ADDENDUM NO. 1
Amelia River Waterfront Stabilization Parking Lots C & D
City of Fernandina Beach
Invitation to Bid # 21-06
Issued: May 25, 2021

III. Changes to Drawings: (See attached)

**INDEX OF
DRAWINGS,
ABBREVIATIONS,
LEGEND & SUMMARY
OF QUANTITIES**

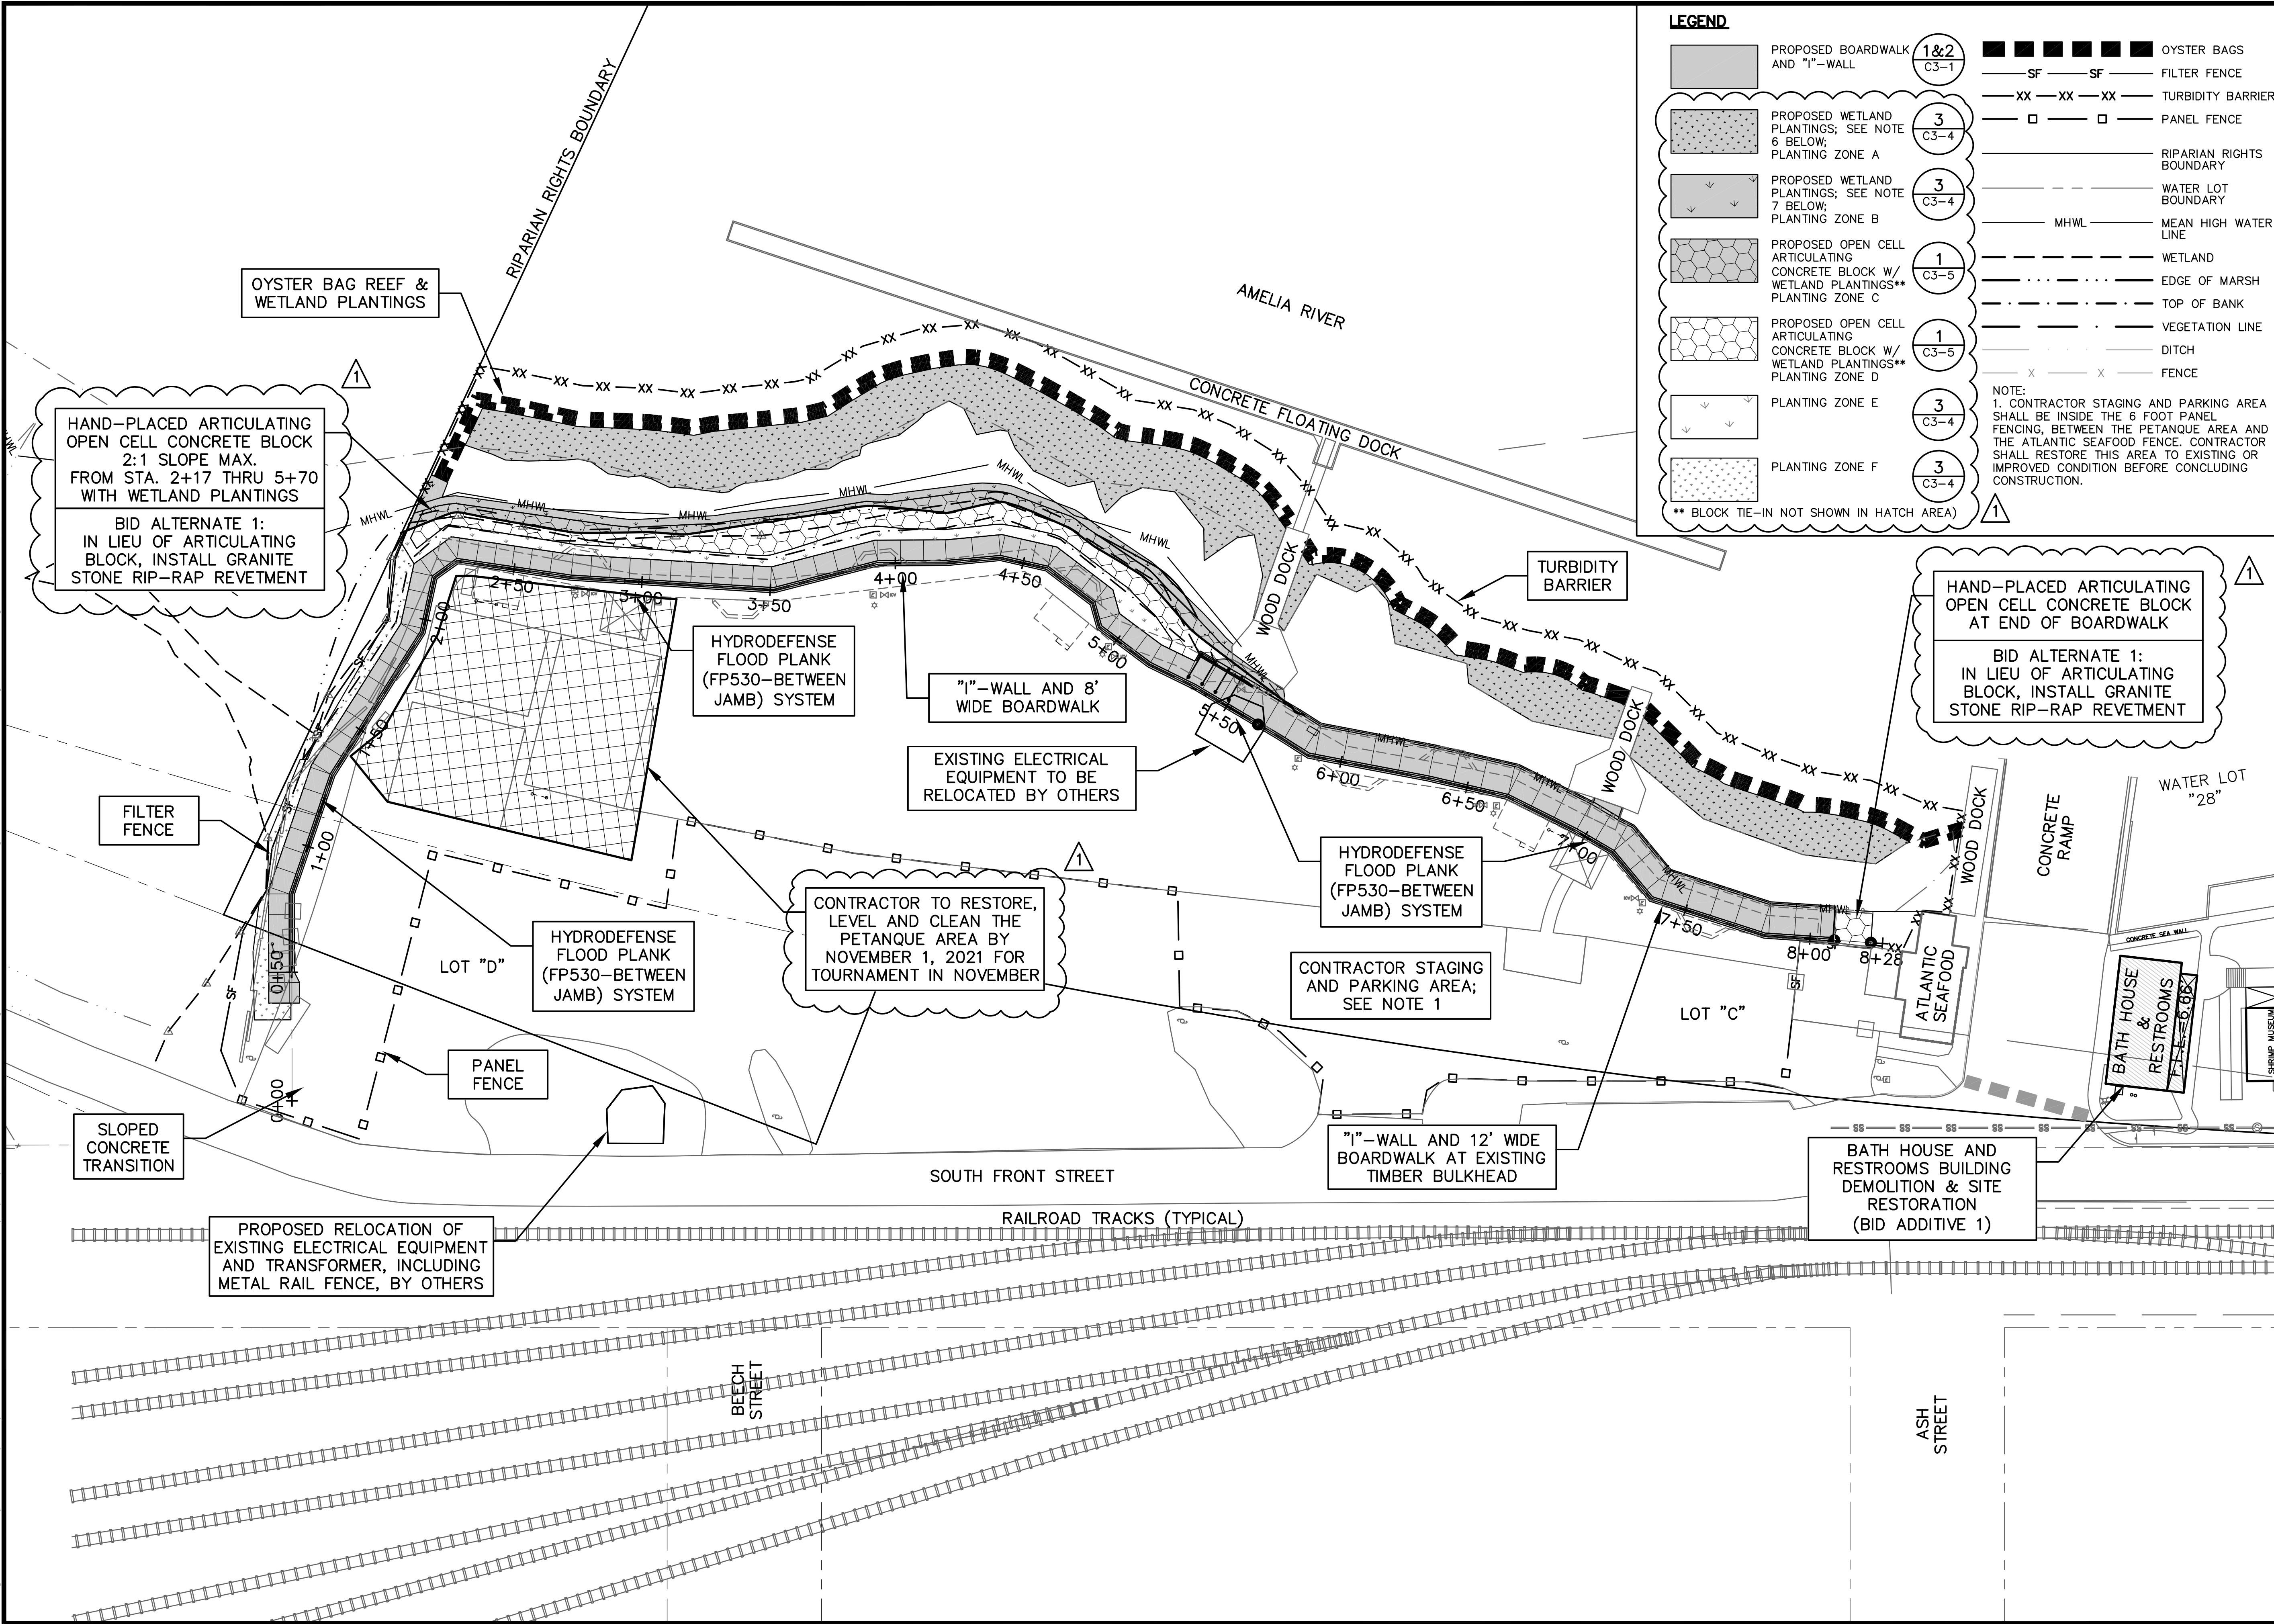
- 1) Sheet G1-2 – Revised Estimate of Quantities.
- 2) Sheet G2-1 – Revised I-Wall & Boardwalk alignment; Wetland Planting Areas and Zones; Petanque Area restore date, Bid Alternate 1.

**DEMOLITION
 PLAN**

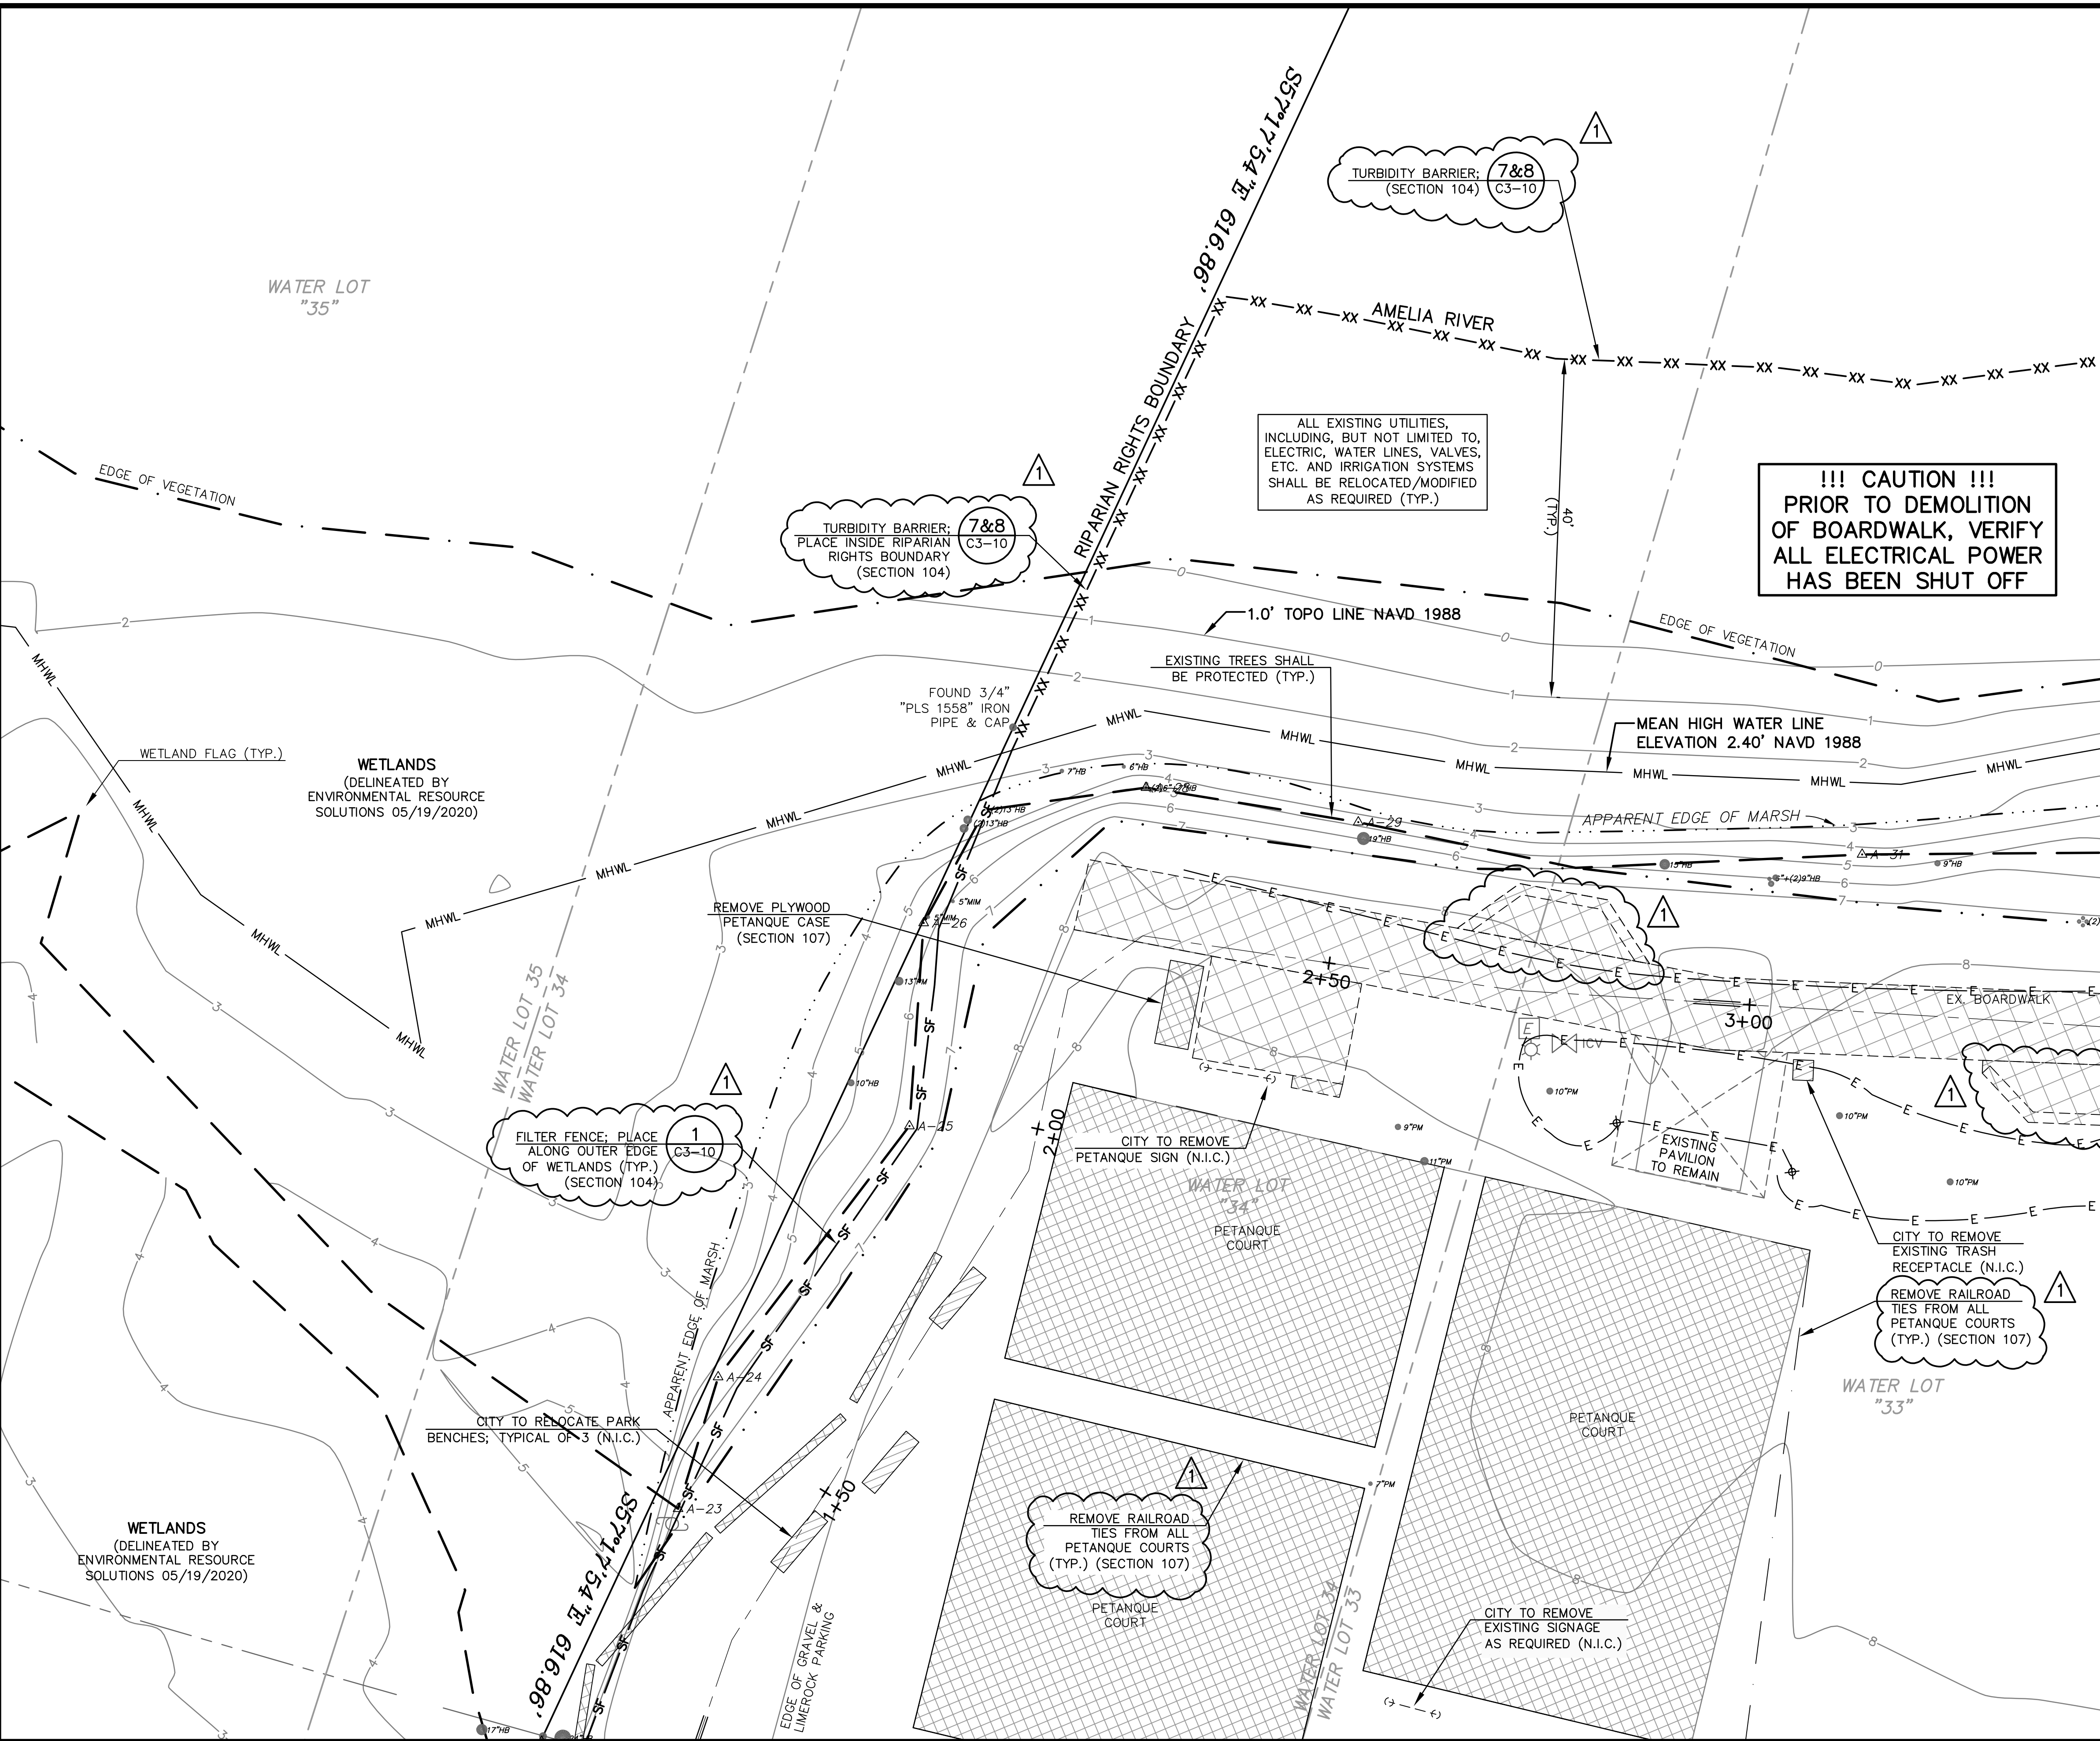
- 3) Sheet C1-1 – Revised Alignment; Survey correction Wetland Flags and Bid Form Section Tags.
- 4) Sheet C1-2 – Revised Alignment; Survey correction Wetland Flags; Tree Locations; Boardwalk Areas and Bid Form Section Tags.

Project No.
99000047.0095
Drawing No.
C2-1
Date
May 25, 2021

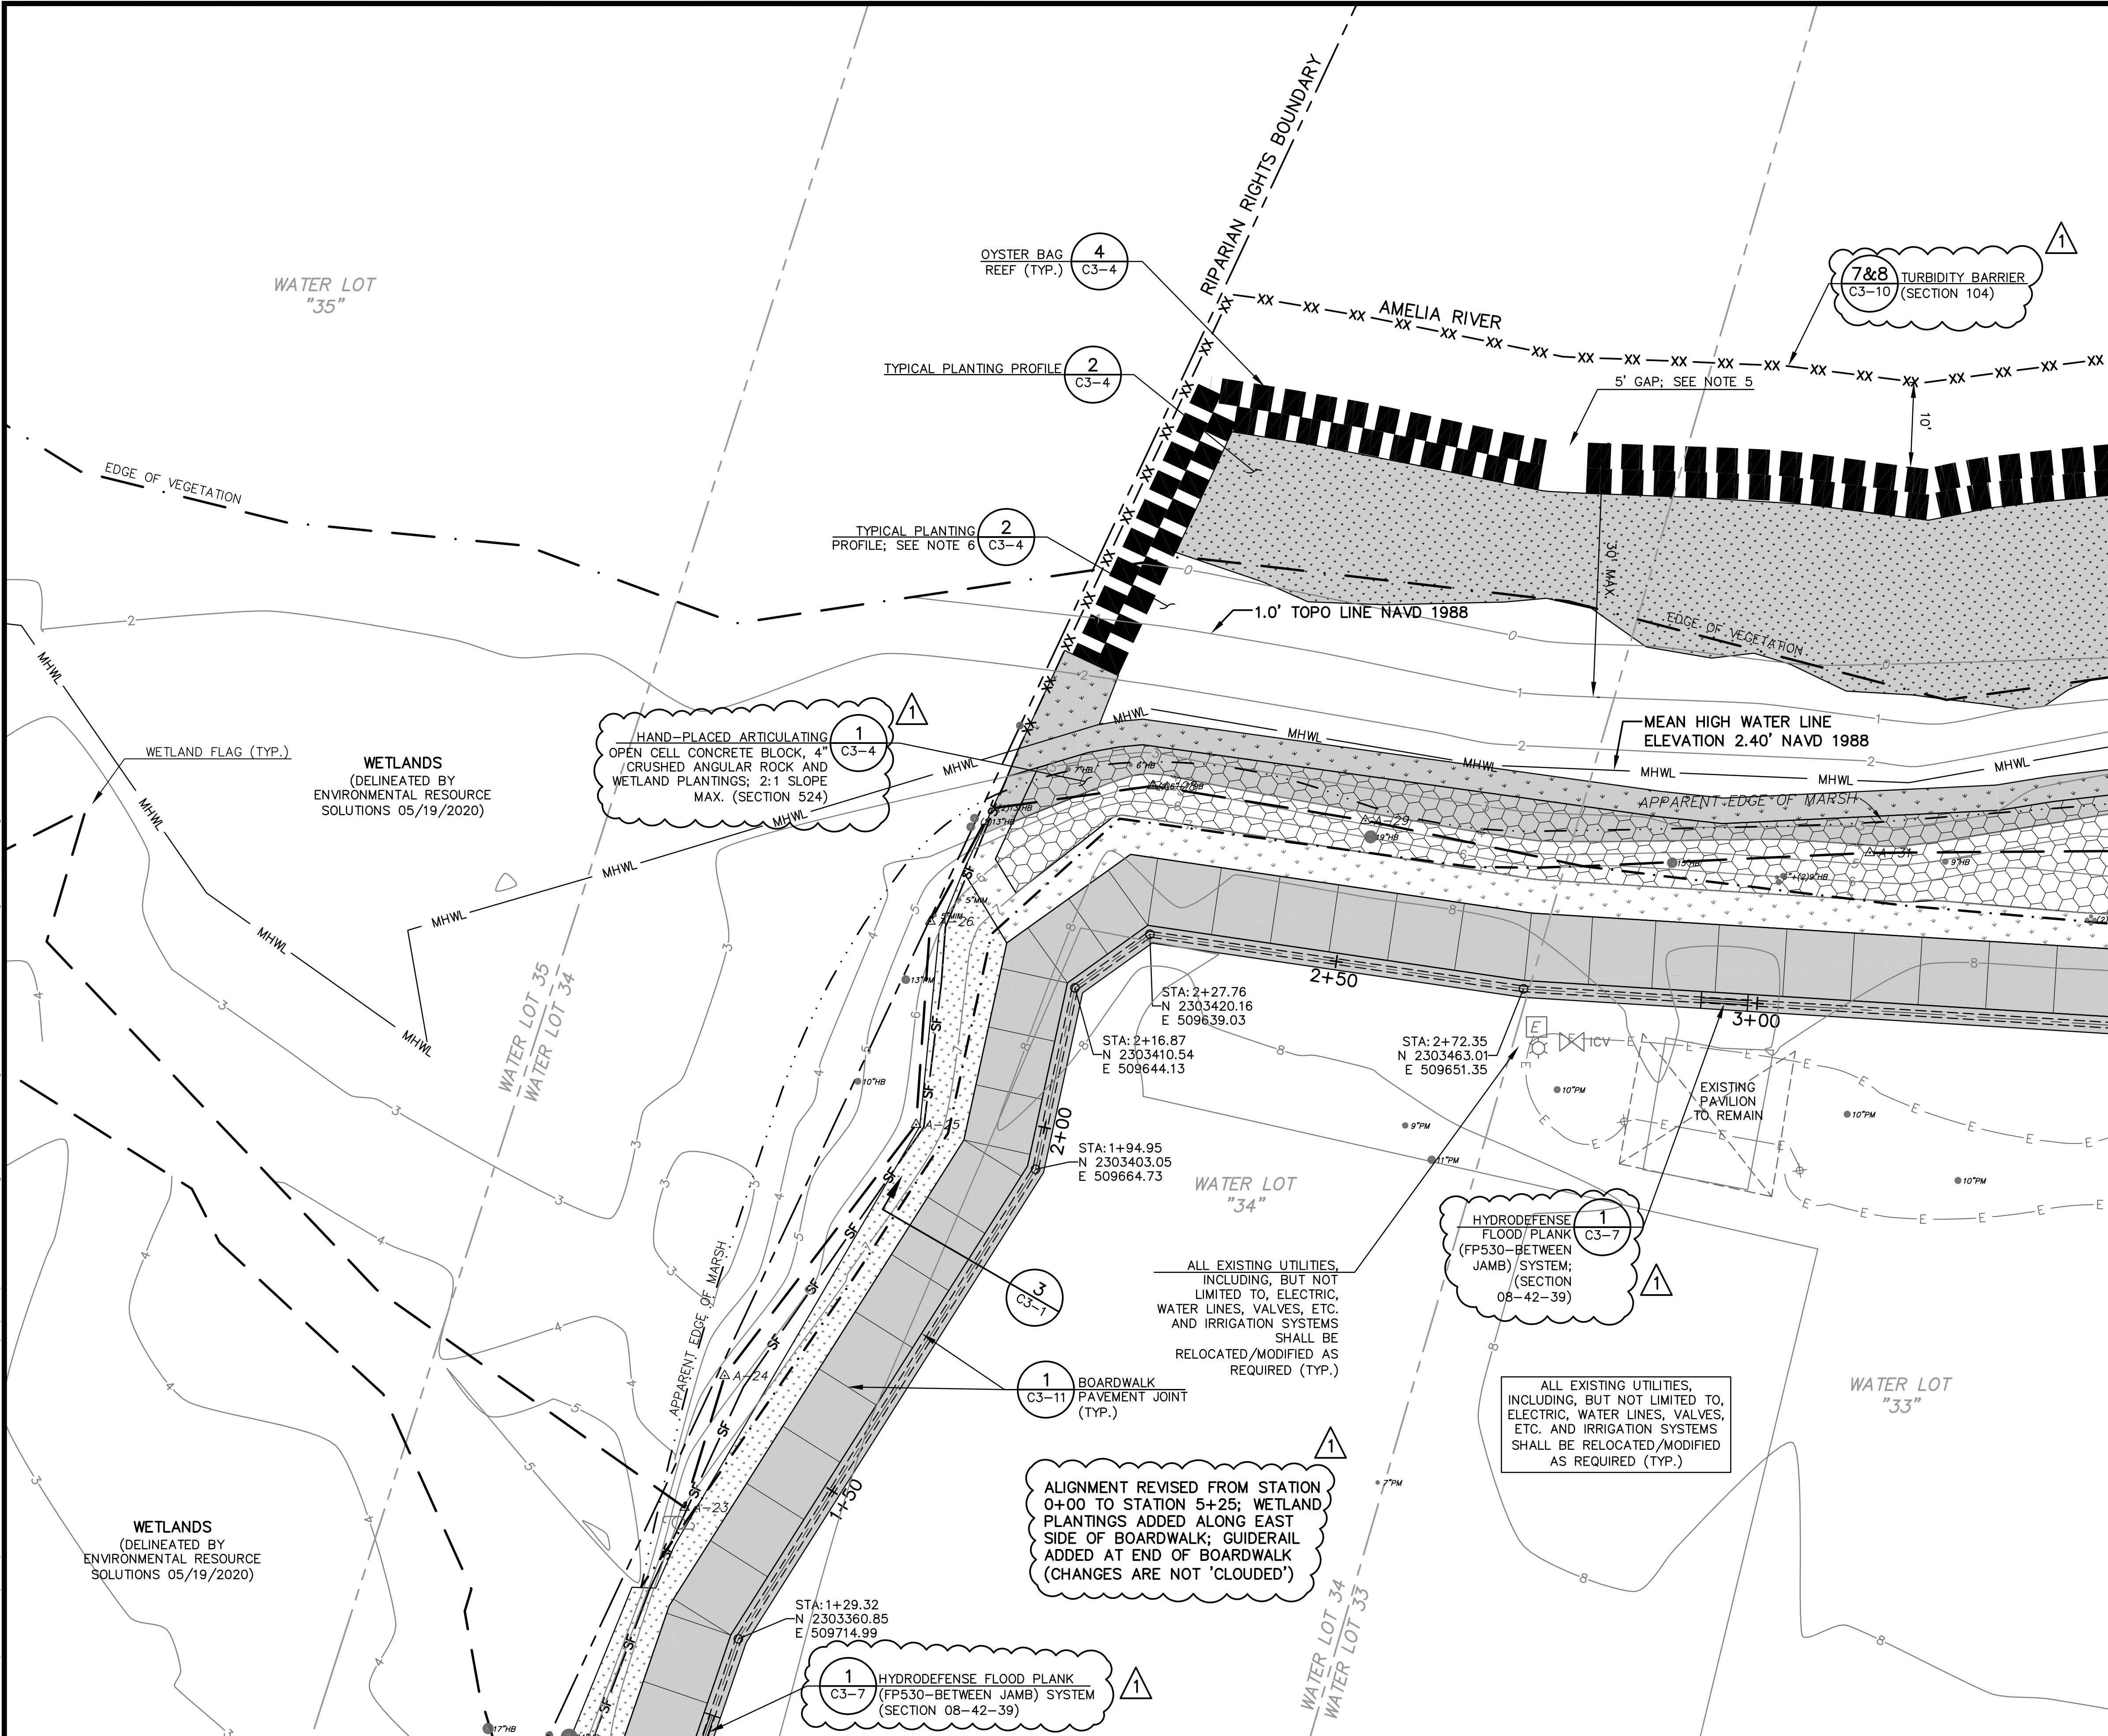
- 7) Sheet C2-1 – Revised I-Wall & Boardwalk Alignment; Wetland Planting Areas and Zones; Survey correction Wetland Flags; Boardwalk transition to Parking Area and Bid Form Section Tags.
